OFFICE OF NEW REACTORS
SUMMARY FEEDBACK ON FOUR KEY LICENSING ISSUES
NEXT GENERATION NUCLEAR PLANT
PROJECT 0748

RESPONSES TO SPECIFIC REQUESTS FOR NRC FEEDBACK

Figure 1. NGNP Frequency-Consequence curve proposed by DOE/INL (ML12262A090).

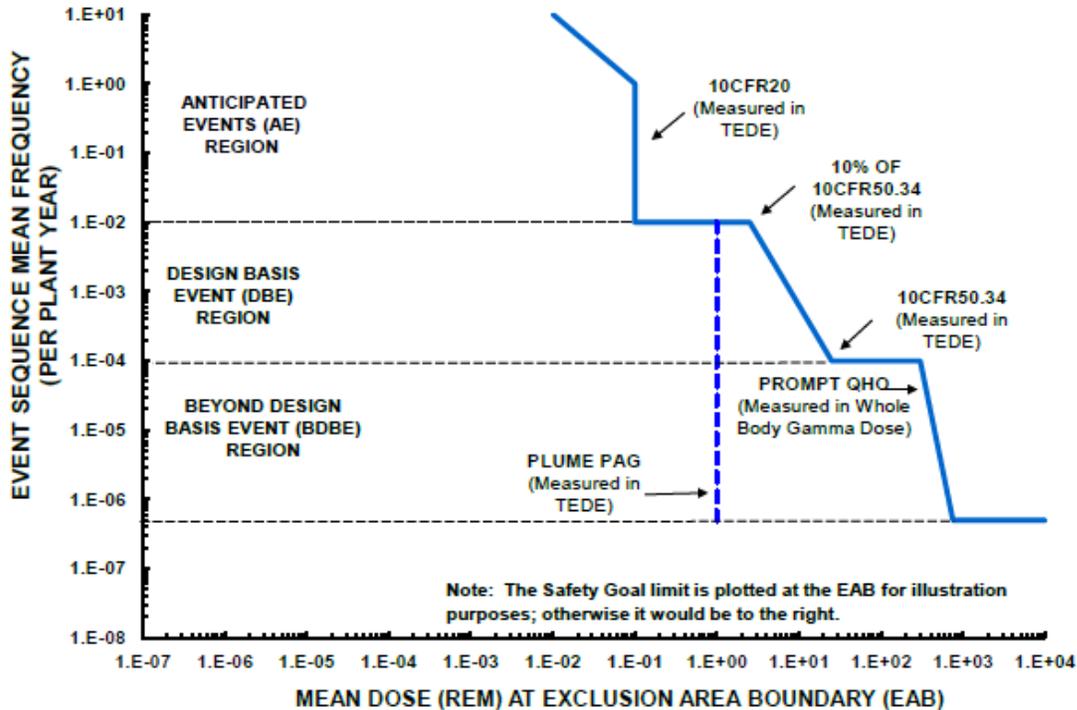
The NRC staff concludes that the proposed approach to placing top level regulatory criteria (TLRC) on a frequency-consequence (F-C) curve is reasonable. Figure 1, a copy of DOE/INL's proposed F-C curve, identifies the regulatory bases for the respective TLRC and displays the TLRC-based dose limits as a function of event sequence mean frequency per plant-year over the proposed event category regions.

- The TLRC for the AE region would be based on limiting the cumulative annual dose to an individual member of the public to 100 millirem total effective dose equivalent (TEDE) as required in 10 CFR Part 20, "Standards for Protection against Radiation." DOE/INL proposes that AE source terms should be mechanistically modeled and that dose consequences should be realistically calculated at the exclusion area boundary (EAB).
- The TLRC for the DBE region would be based on an event-based public dose criterion of 25 rem TEDE as required in 10 CFR 50.34, "Contents of Applications; Technical Information."⁷ DOE/INL proposes that DBE source terms should be mechanistically modeled and that dose consequences per event sequence should be conservatively calculated at the EAB.

- The TLRC for the BDBE region would be based on cumulative public dose limits derived from the quantitative health objectives (QHOs) of the NRC safety goals, whereby the QHO for prompt fatality is the most limiting. DOE/INL proposes that BDBE source terms should be mechanistically modeled and that offsite dose consequences should be realistically calculated.

The TLRC are used with the F-C curve to establish limits on the frequencies of event sequences and their radiological consequences. The F-C curve and its TLRC are then used in the categorization and evaluation of LBEs and in characterizing the treatment of SSCs. The overall approach provides a logical technical basis for ensuring and demonstrating that the design meets applicable regulatory criteria for public health and safety. It further bears noting that this approach is largely consistent with the staff's approved recommendation in SECY-03-0047 regarding Issue 4 in that it places greater emphasis on the use of risk information by allowing a probabilistic approach in the identification of events to be considered in the design and licensing.
